2 Type of change

Change of material

Product Change Notification					PCN MGA series change of blister belt		
owner	creation date	release date	released by	change order no	rev	page	D10-042-010
elmigeth	08.01.2021	08.01.2021	haeckima	2018992	B	1 of 2

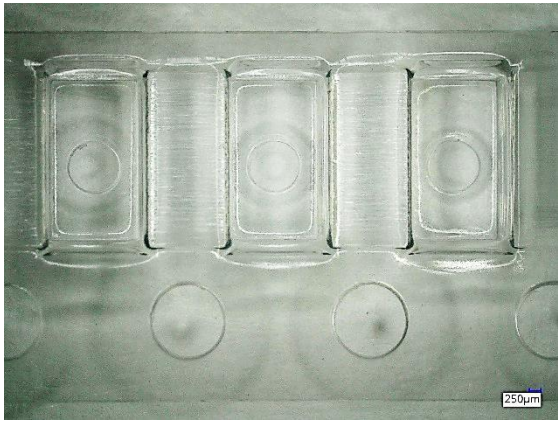
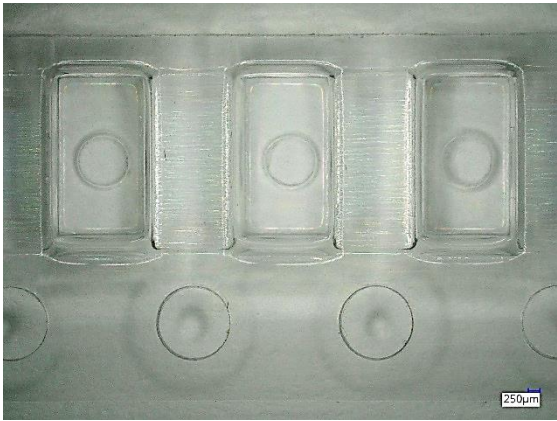
Old product description	New product description
H-PVC transparent, shiny, antistatic	PET GAG, volume antistatic, transparent
Old product picture	New product picture
